City of Portland, Maine – Building or Use Permit Application 389 Congress Street, 04101, Tel: (207) 74-8703, FAX: 874-8716

BUILDING PERMIT REPORT

DATE: 9 MAY 98 ADDRESS: 45 Buca Run (LOT #18) 336-E-068
REASON FOR PERMIT: To Construct a single Family dwelling
BUILDING OWNER: Diversified Properties
CONTRACTOR: Custom Built Homes of Maine
PERMIT APPLICANT: Danny McCarthy
USE GROUP R-3 BOCA 1996 CONSTRUCTION TYPE 5-B

CITY OF PORTLAND, ME
BOCA 1996 Plan Review Record
One and Two Family Dwelling

LOT # 18 BUCCA RUN

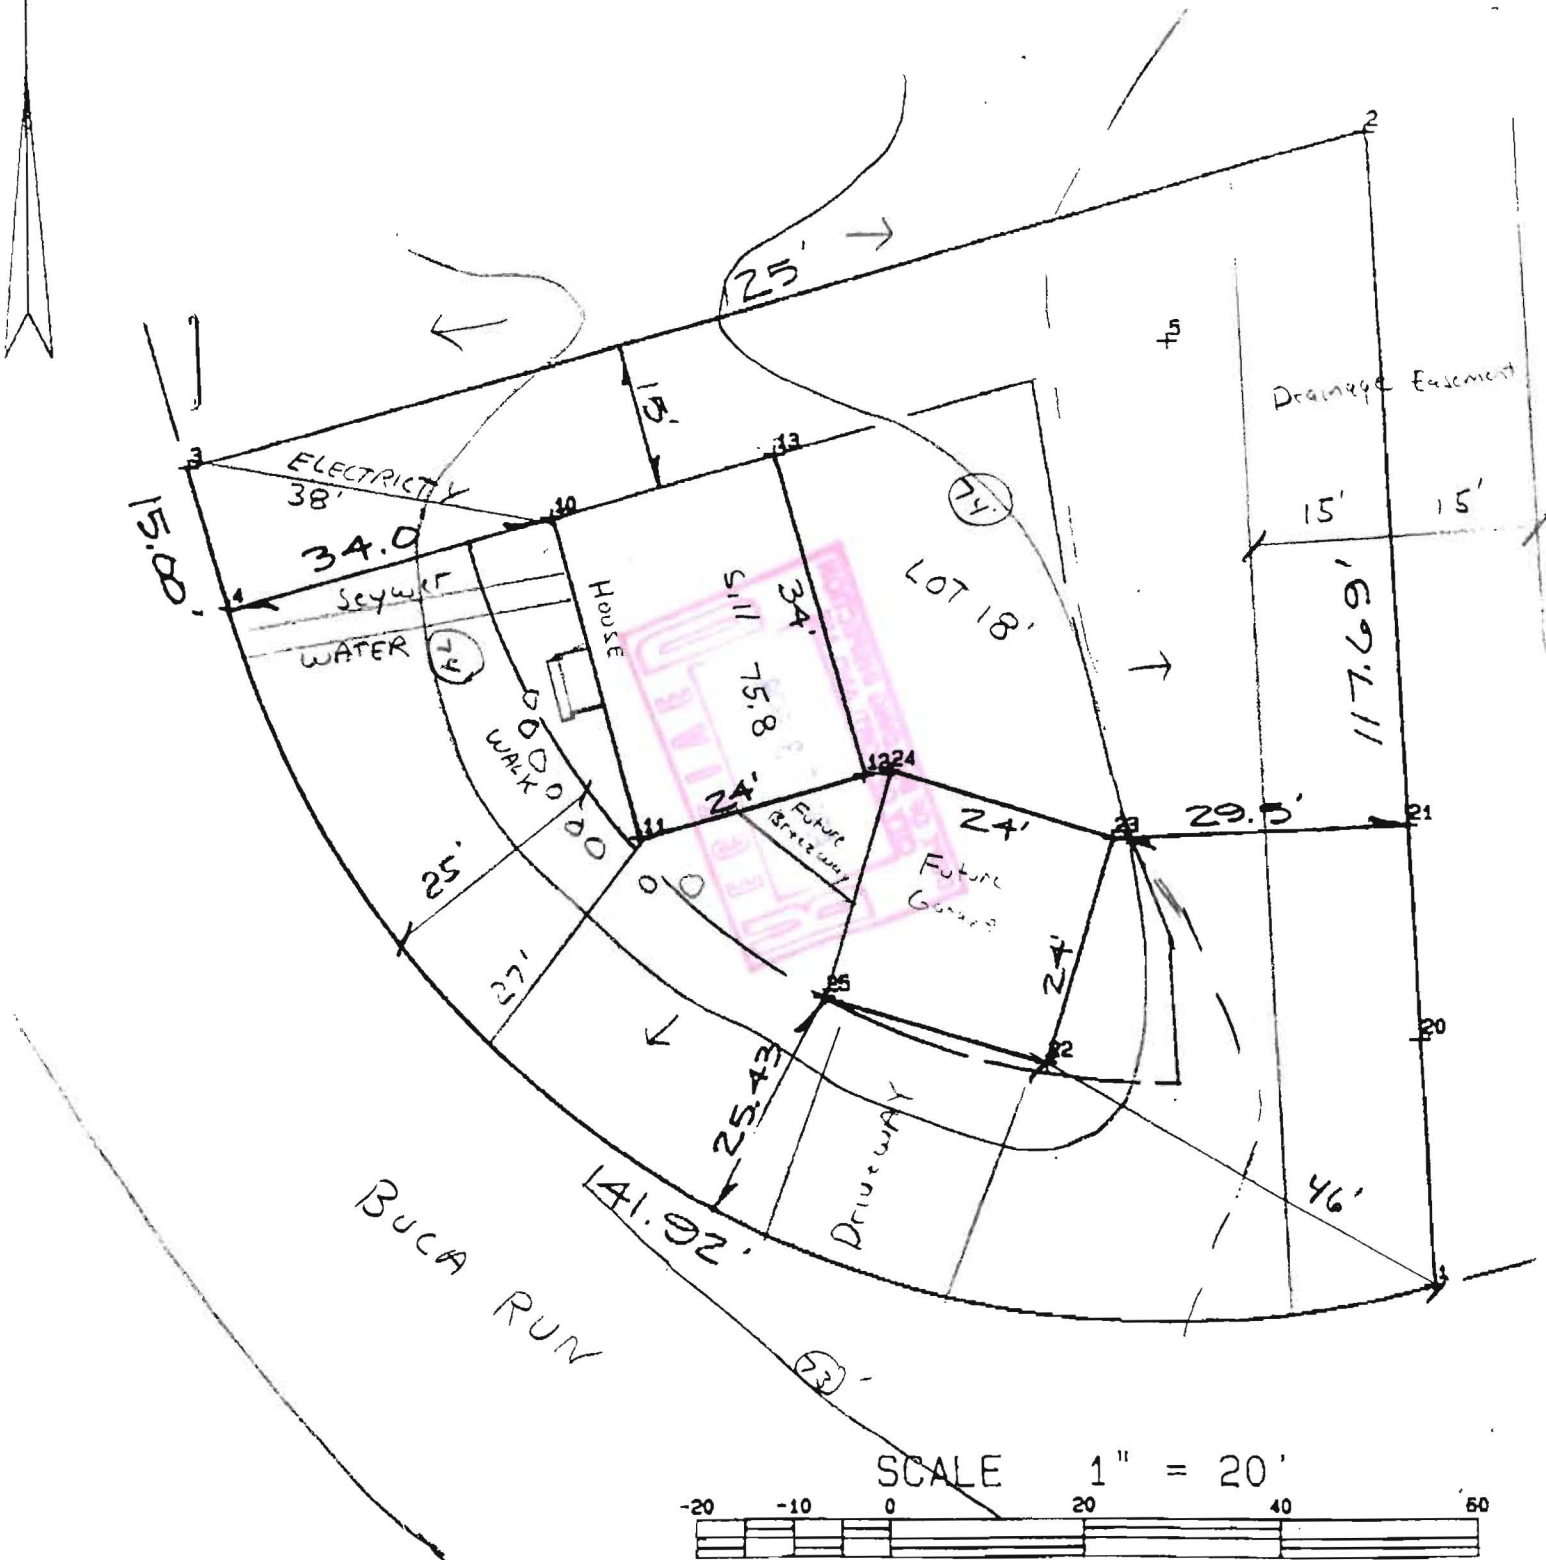
Front Yard - 25' req - 25'± show (Be Careful) Very Close

A drainage plan shall be submitted to and approved by Development Review Coordinator showing first floor elevation (FFE), sill elevation (SE), finish street/curb elevation, lot grading, existing and proposed contours, drainage patterns and paths, drainage swales, grades at or near abutting property lines, erosion control devices and locations and outlets for drainage from the property.
